From: [Joann Meneaud](#)
To: [Paul Roberts](#); [Christien Lee](#); [Peter Dutton](#)
Subject: FW: Hill Farm, Hempsted appeal 20/00315/OUT drainage
Date: 20 July 2022 08:42:23
Attachments: [image010.png](#)

Hello,
Sorry if this is a bit confusing but here are the comments in relation to surface water drainage.

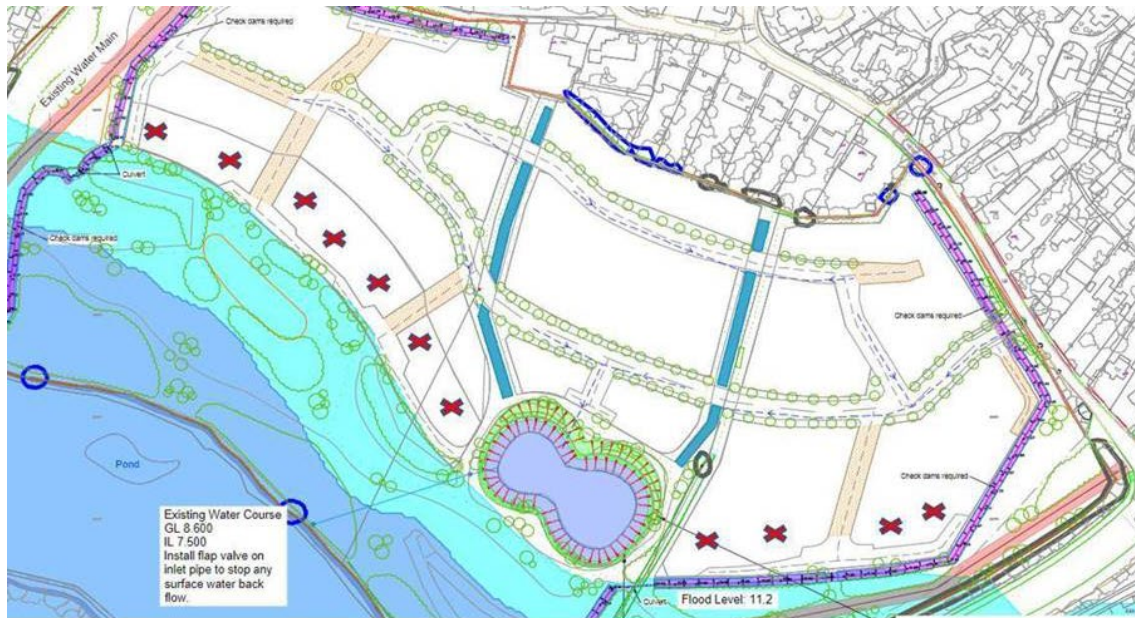
I have some questions over the discharge rate / attenuation volume calculations.

A QBar value for the site of 17.3 l/s has been calculated based on a developable area of 6.3 ha.

However, the attenuation volume calculations seem to have been calculated based on the smaller (impermeable) area of 3.52 ha, with no allowance for the permeable areas.

The runoff from the permeable areas has to go somewhere. It will either:

1. Be captured by the on-site drainage - in which case that area can be included in the QBar calculations, but the attenuation volume calculations will need to make allowance for the runoff.

or

2. Not be captured by the on-site drainage – in which case that area should not be included in the QBar calculations.

Where runoff volumes are being calculated for a defined area of impermeable surfacing (as they are here), we would normally expect the cv value to be 0.95. Here, Cv values of 0.75 / 0.84 (summer / winter) have been used. Clarification is sought.

The permissible site discharge has been re-calculated at 10.3 l/s which seems like an appropriate rate.

The attenuation volume calculations don't make any allowance for the capture of runoff from permeable area. Presumably some permeable area (that uphill of new drainage provision) will contribute surface water runoff to the new drainage network. An allowance is needed here. Sometimes we see 20% of contributing permeable added at 100% runoff. **This has now been done. ok**

Further notes on attenuation basins:

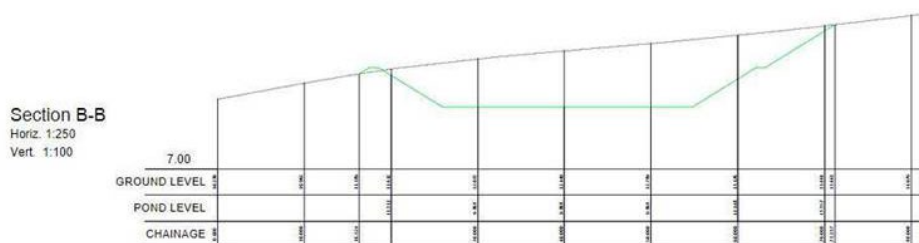
It is particularly important that SuDS attenuation basins are well designed and well integrated. Basins should be as naturalistic as possible with varying side slopes (max 1 in 4). If they are to form part of public open space / play space they should have good access. Low flows should be channelled within a shallow swale within the basin so the basin is kept as accessible (dry) as possible for as much of the time as possible, unless the basin is designed as a wet pond. The photo below shows the style of basin preferred. A permanently wet area is good for wildlife.

- Basins to incorporate a 3.5 m wide safety / maintenance bench around the perimeter.
- Basin sides to have varying gradients (max 1 in 4)
- Inlets and outlets to be finished in pitched stone rather than RC concrete
- Key clamp railings to be avoided
- Basin topography to be as naturalistic as possible. In particular, unnatural looking bunds and 'perched' basins are to be avoided
